FINAL DRAINAGE REPORT FOR SOLACE AT CIMARRON HILLS

> March 12, 2021 Project No. 25174.00

PCD File No. PPR-20-047 PCD File No. SF2032

DETENTION BASIN OUTLET STRUCTURE DESIGN

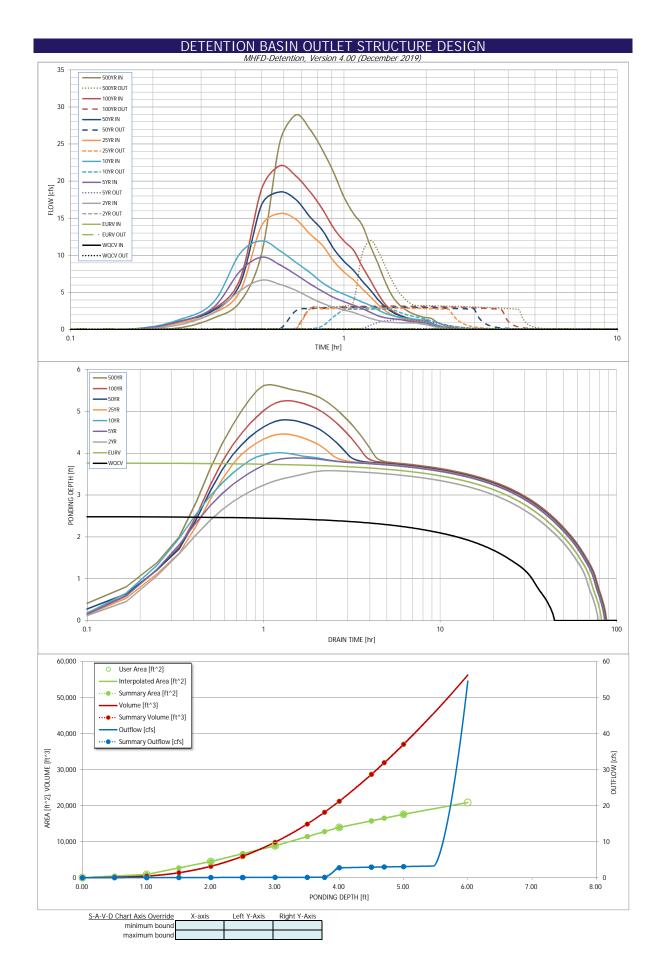
Revise to design drain time to be within 40 hours for extended detention basins per state statute 15-212.

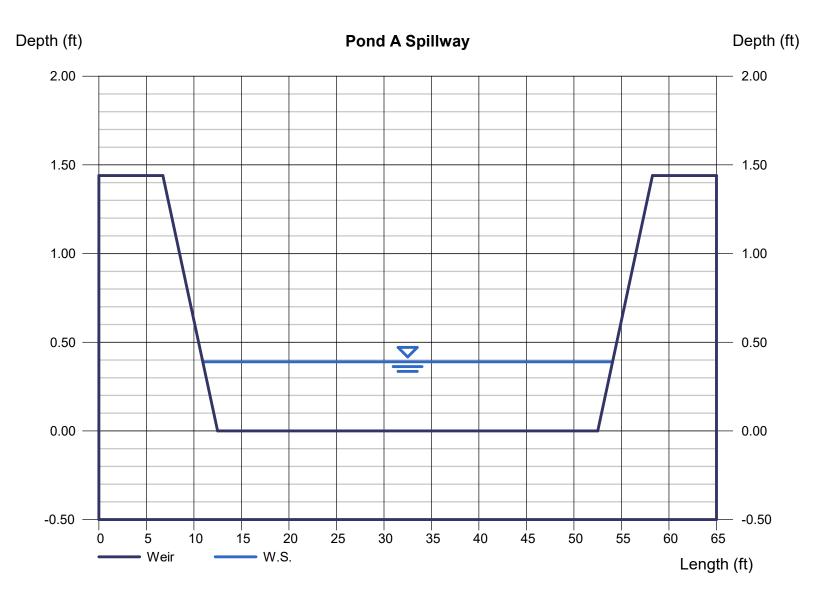
Side slopes are 10% in all other documents. Revise to

remove inconsistencies.

DETENTION BASIN OUTLET STRUCTURE DESIGN

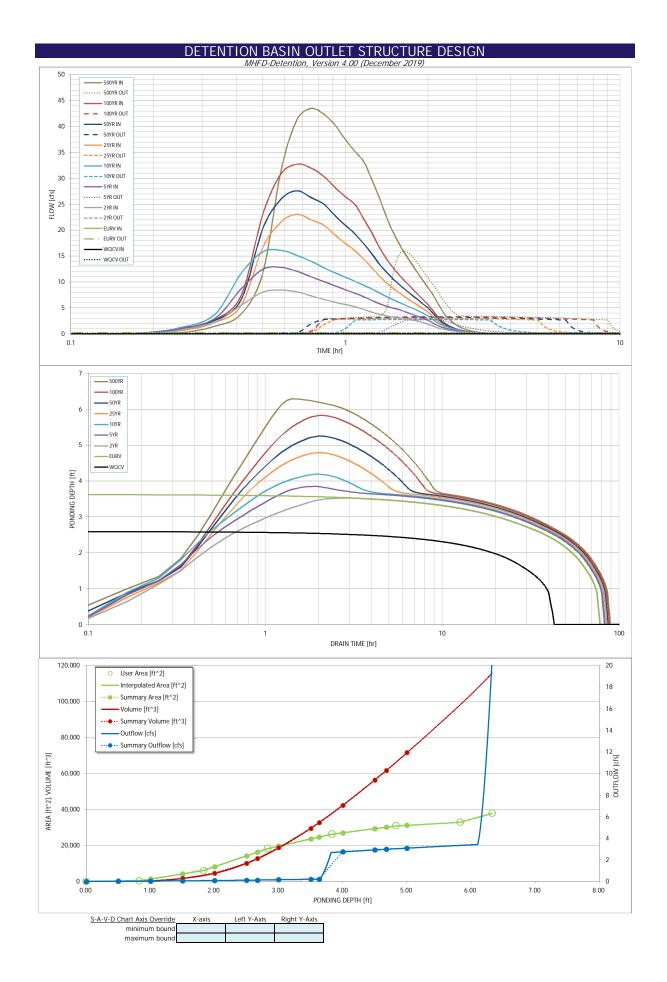
Revise to design drain time to be within 40 hours for extended detention basins per state statute 15-212.

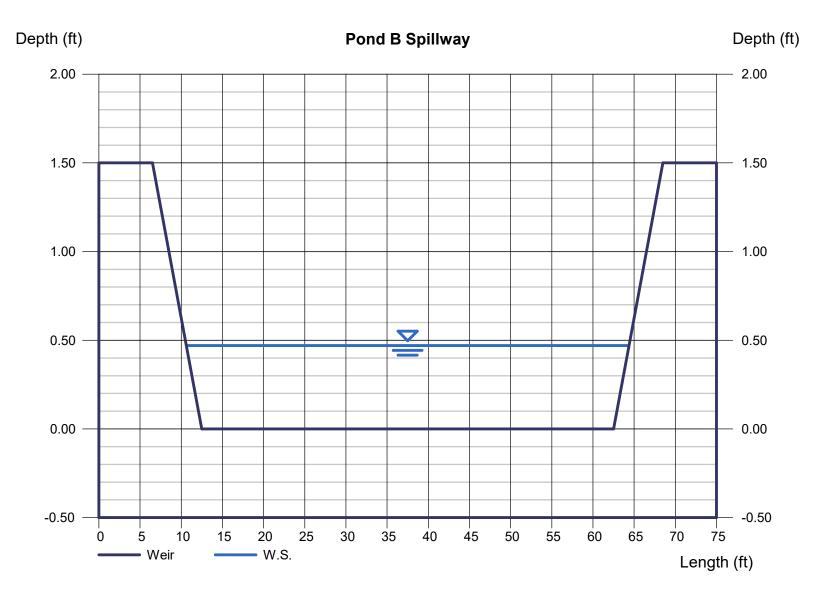
Side slopes are 10% in all other documents. Revise to remove inconsistencies.
